Central Planning Authority

Minutes of a meeting of the Central Planning Authority held on **May 25, 2022 at 10:00am** in **Conference Room 1038, 1st Floor, Government Administration Building, and Elgin Avenue.**

CPA/14/22

Figure 2: A plan extract showing the area of the proposed building, septic tank and car parking within the 20ft rear boundary setback (Island Drafting Ltd.)

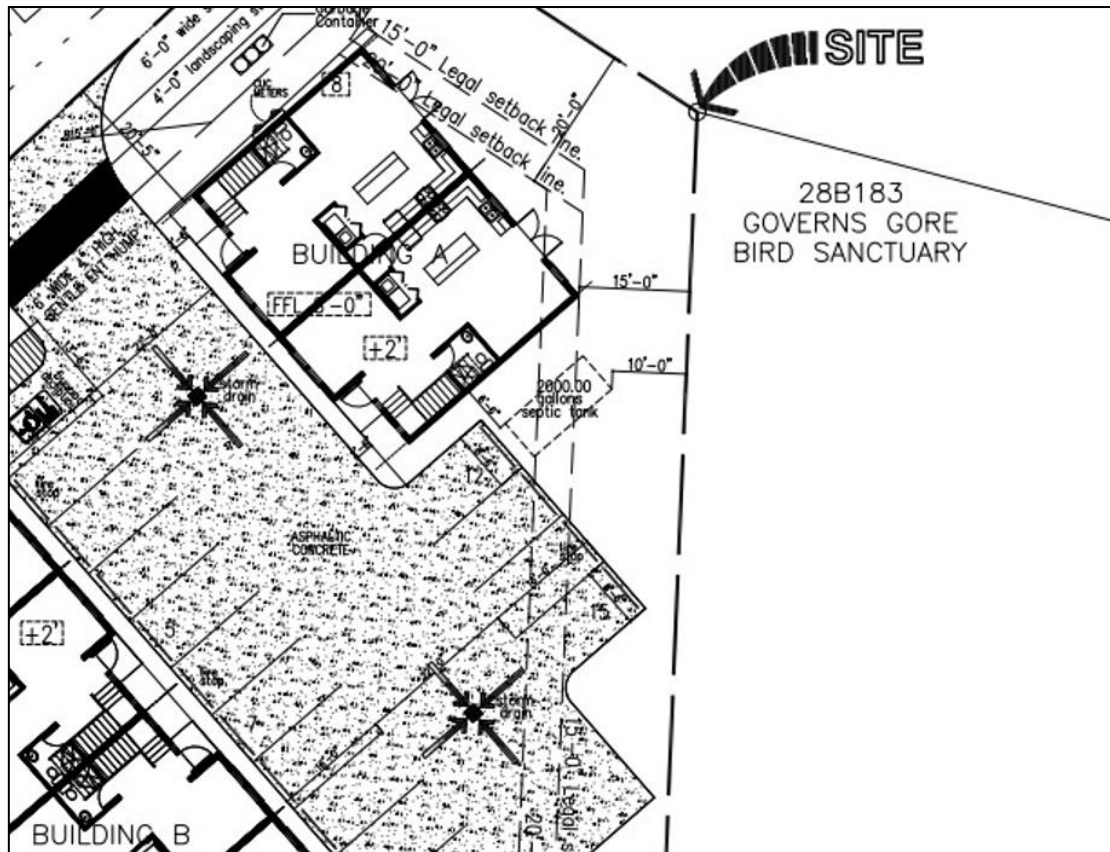
Although the Development and Planning Regulations (2022 Revision) require a 20ft minimum rear setback, currently the plans propose a 15ft setback for one section of the proposed northern apartment building and the septic tank and an approximate 4ft setback of the car parking area, as shown in Figure 2 below.

Should the Central Planning Authority or Planning Department be minded to grant planning permission for the proposed development we strongly recommend the inclusion of the following is listed as conditions of the approval:
